WELL COMPLETION REPORT

SITE INSPECTION SHEET

ADDRESS: 3560 WOODBINE RD. CONTRACTOR: _____

LOCATION DIAGRAM

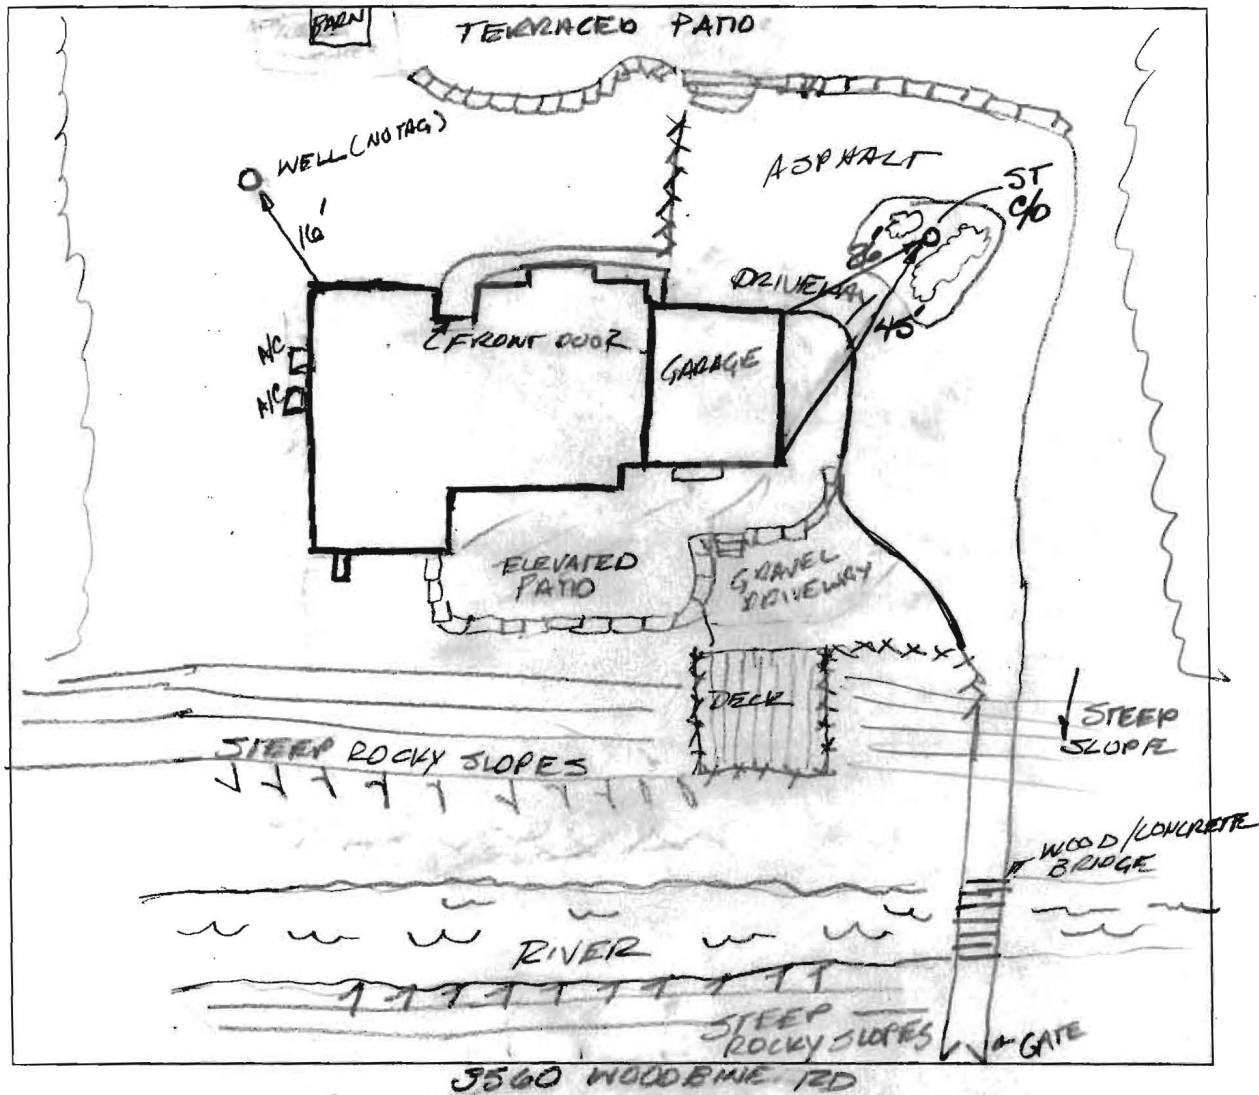
COMMENTS: WELL HAS OLD CAP w/ SAFETY LINE BETWEEN CAP & CASING; NO TAG ON WELL; COULD NOT LOCATE LOCATION OF SEPTIC. CAP ON WELL SHOULD BE REPLACED. STATUS OF SEPTIC SYSTEM SHOULD BE DETERMINED BEFORE APPROVING ANY BUILDING PERMITS. SEPTIC WORK MAY BE REQUIRED.
